Aqueous Solutions (owner) AQS-MFG-TI_CELL-HD01
TI_CELL fabrication drawing HD01 (AQS-PLAN-006 M3; graph Rev
Type: fabrication drawing (GA / nozzle orientation / part sheet) Rev a2c17069 Issued
Created: flow graph pipeline Approved: not approved (study)
Sheet 1 of 1 AQS-DWG-001

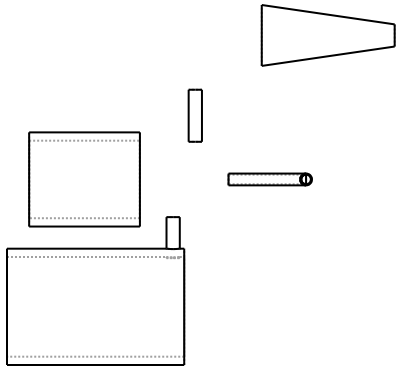
Graph revision AD - hd01: Chlorinator heater band and condenser water band, OD +30 shells, element pockets per the duty sheet
Graph revision AD - hd01: Mg charge hopper cone on the retort; interconnect stubs OD 24 t 2 with full-penetration butt welds (ISO 2553)
Graph revision AD - hd01: N14 vent riser DN15 from the condenser top to the z 800 datum
Graph revision AD - hd01: General tolerance ISO 2768-m unless noted
